35–039 Detroit New Final Drive Standard Performance Forward Carrier Change to Top Performance Passive Lube Management

TSB-35-039-FTL

Fig. 1, Original Standard Performance Carrier without a Lube Management System

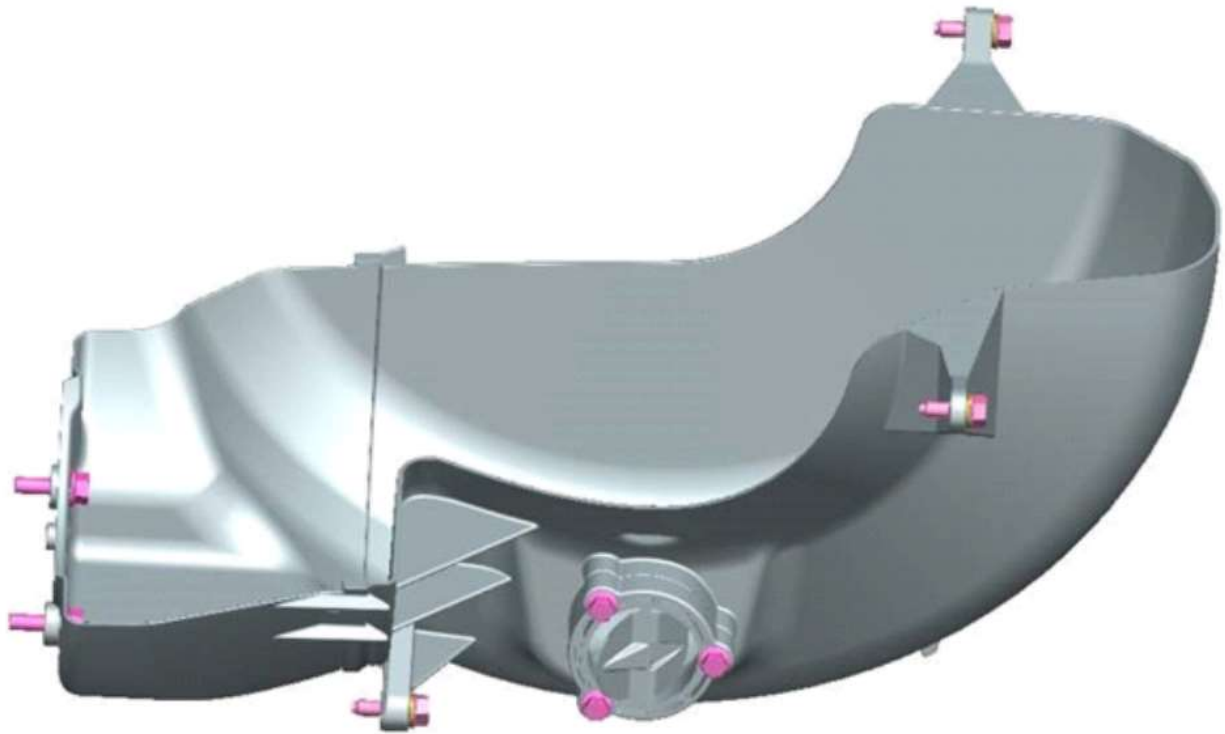
Detroit New Final Drive Standard Performance Axles will have a change to the lube management system. Initially launched without a lubrication management system, the forward rear axle will change to a passive management system. This will be the same passive lube management system as the New Final Drive Top Performance Axle with passive lube management.

The parts will supersede in Excelerator. This change is happening to the forward-rear carrier only. See Fig. [1](#), Fig. [2](#) and Fig. [3](#).

Fig. 6, Old Fill Plug

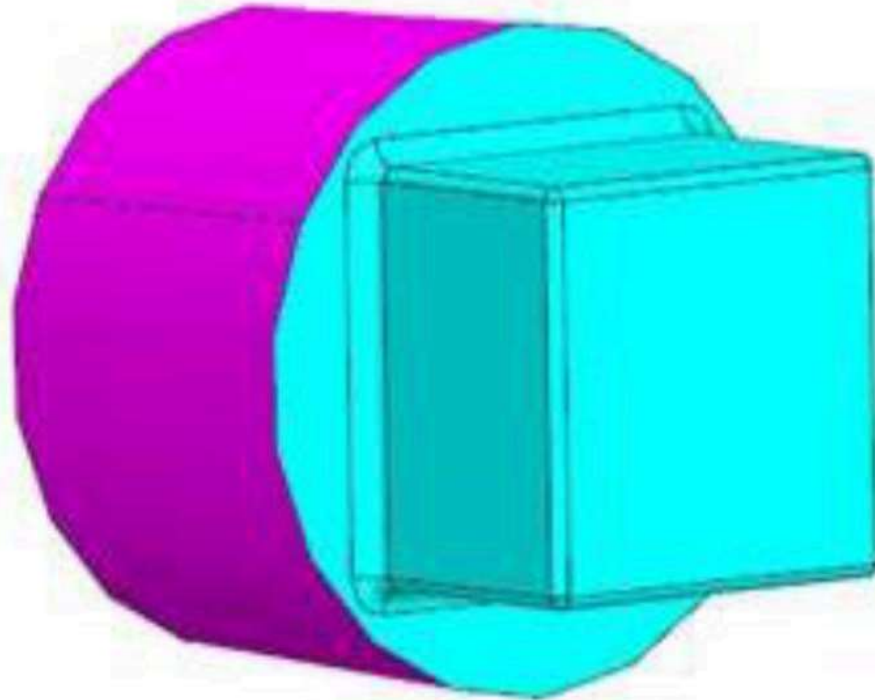
Oil fill locations will change to match the New Final Drive Top Performance locations. See Fig. [4](#). The type of approved oil is DFS93K219.01 only. The rear fill plug part number on the axle housing will change to a new part number (MBA 6809900117), and it will be installed from the inside, similar to the Top Performance carrier. See Fig. [5](#).

1. In order to replace the carrier, clean the housing, and remove the external fill plug from the axle housing.
2. Install the new fill plug (MBA 6809900117) from the inside of the housing. See Fig. 6 and Fig. 7.
